# CONSTRUCTION VALUE ENGINEERING CHANGE PROPOSAL MISSOURI DEPARTMENT OF TRANSPORTATION

MISSOURI	DEPARTMENT OF	TRANSPORTATION	
Contract ID 090925-703		Date	3/11/10
County Vernon	Route 71	Original Bid Cost \$271,	194 15
Contractor APAC-Missouri, Inc.	a 32	By Tyson Collins	177110
Designed By APAC-Missouri, Inc.		Phone 417-868-6700	
VECP - 10-51			<u> </u>

JOB NO: J7P0863

Rt. 71, Vernon County

STA. 747+95.00 -> 766+04.13

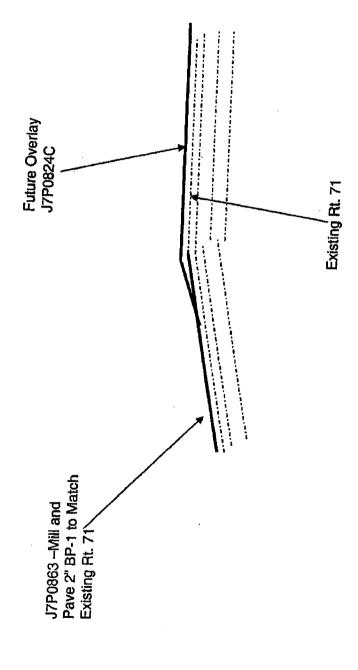
1. Description of existing requireme	nts and proposed char	nge(s). Advantages/Disadva	antages
Proposed Change in Pavement. This Value Engineering Proposal is replacement. The original design of to 766+04.13 on the north and south 2" below existing grade and place 2 (see attached typical section). In adeliminated in this area. This proposa are not removing pavement on exist Type C Barrier wall that will need to the small quantity. A significant quiproposing to lay the A-2 shoulder or provide MODOT with another altern offs. This operation would also elim during construction of the median or save Missouri tax payer dollars. Save Engineering Specifications.	alls for full depth replace in bound lanes. By eliming mate dition, the need for subulation also eliminates striping Rt. 71. There will be be constructed. APAC antity change has increased dirt, eliminating all banative other than removing a much safer environgs will be spit 50%/50	cement for A-2 shoulders from the continuing excavation in this area cerial to match flush to existing a grade preparation and base rong and rumble strips for this pube 62.6 SY of A-2 shoulder upon C is proposing to change the based the price of the A-2 shouldes erock. The advantage of the ring structural pavement and cong a lane drop up on Rt. 71 for vironment for the traveling public (MODOT/APAC) in acceptance of the congression of the congress	n station 747+95.00 a, APAC will mill g Rt. 71 pavement ock would be project, because we inder the proposed bit base to BP-1 for alder. APAC is also e change is to creating edge drop or several days ablic and would also ordance with Value

Mill	and fill existing s	shoulders in lieu o	of remove and r	eplace.

•	
** P	ortion Below This Line To Be Filled Out by MoDOT **
Comments:	or of this proposal with the stipulation that desina
И Л.	1.12 I fam is maintained air to the
The removal process	a solin roundation is maintained prior to the
placement of the 2"	overlay. It poor conditions exist within the limits of
the original proposed	42-shoulder, and tional depth of BP-1 may be required
The original proposed	3-11-10
	Dayment Dy Resident Cugnion 1746
placemen tof the 2'the original proposed	or of this proposal with the stipulation that human a solid foundation is maintained prior to the overlay. If poor conditions exist within the limit 42-shoulder, additional depth of BP-1 may be 18  Submitted By Resident Engineer Date
